OPTIONAL SERVICE BULLETIN NO. OSB 62-004 REV. 1
SUPERSEDES OSB 62-004 REV. 0

Switch between Passenger Seat Row 2 (7-seat configuration) and Rear Baggage Compartment (5-seat configuration) and vice versa.

WORK INSTRUCTION WI-OSB 62-004 REV. 1
SUPERSEDES WI-OSB 62-004 REV. 0

Figure 1. Interior placards.

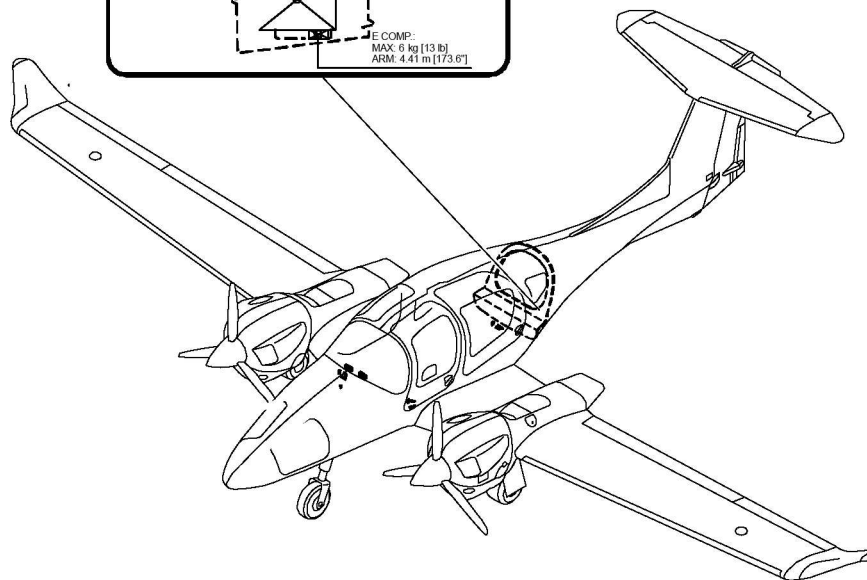
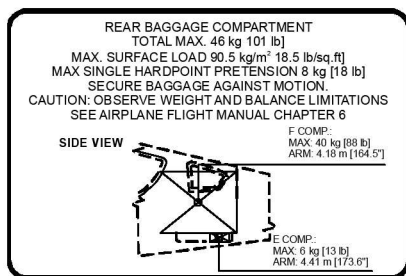
6. Install placards. Refer to Figure 1 and AMM Section 11-00-00, Paragraphs 2A and 2B. Replace the Placard P/N D67-1133-20-19X01 with Placard P/N D67-1133-20-1_01.

6. Install placards. Refer to Figure 1 and AMM Section 11-00-00, Paragraphs 2A and 2B. Replace the Placard P/N D67-1133-20-19_01 with Placard P/N D67-1133-20-1X01.

if OÄM 62-019 is NOT installed
 Placard PN:D67-1133-20-19_01

if OÄM 62-019 is installed
 Placard PN: D67-1133-20-19X01
